ATTENTION!

PLK DESIGN 2 (6) replaces PLK DESIGN 1 (5) and most PLK DESIGN 1 (5) C-numbers
Where applicable, PLK DESIGN 1 (5) and C-numbers have been automatically converted

PLK DESIGN 2 (6)

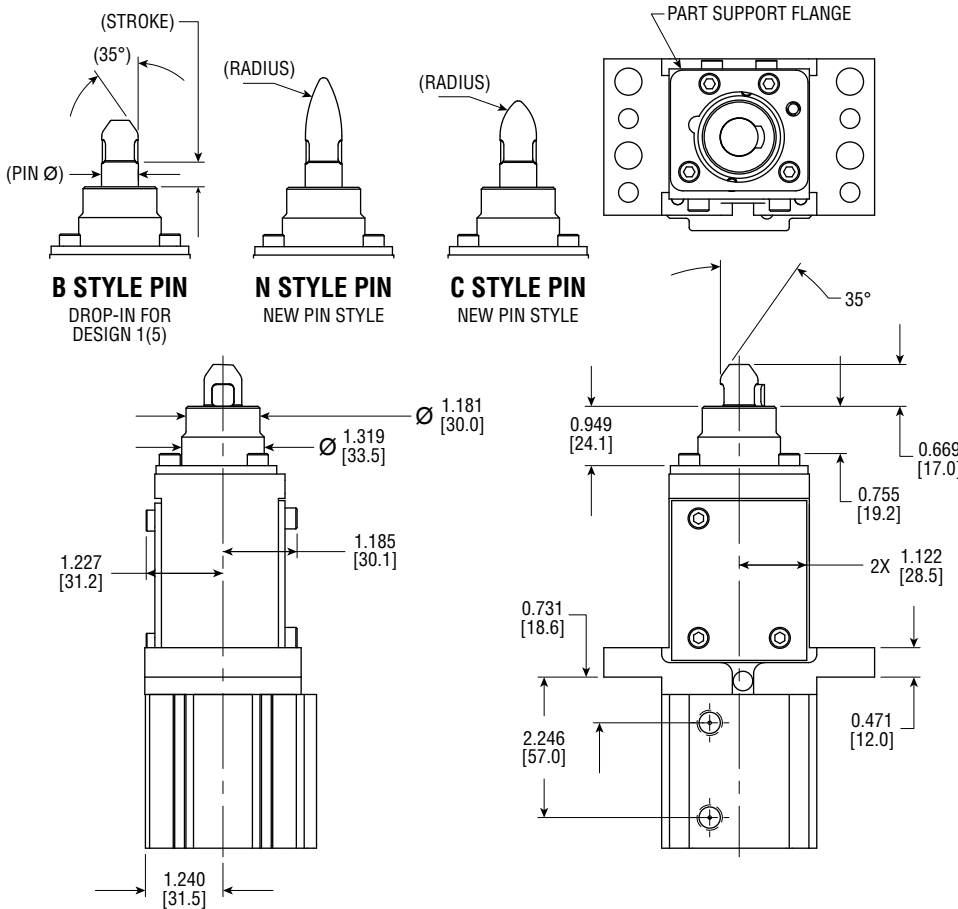
- 2 strokes (505 & 510)
- Imperial (2) & Metric (6) Ports
- 1800 pin diameters 12.00 thru 30.00 (+.00/- .02 mm Tolerance)
- 3 Pin Styles (B, C & N)
- Std. Flange Mount Height (110 mm to 140 mm - .5 mm increments)
- 4 Std. Finger Directions (Easily changed in the field)
- Standard Single Finger and Dual Finger (15 mm dia and above)
- Port Position 1 thru 4 (available with all positional sensing options)
- Port Fittings (-LAA & LBB)
- Cylinder Options (-R01 & R02)
- Cylinder Switch options (SW00, 41, 42, 51 & 52)
- Additional Rear Mounting options standard (-B01 thru -B06)
- Lock Setting (-MT00 thru -MT40) (See page 2 for new lock adjustment procedures)

Previous PLK DESIGN 1 (5) and associated C-numbers are only available as Unique Solutions®.
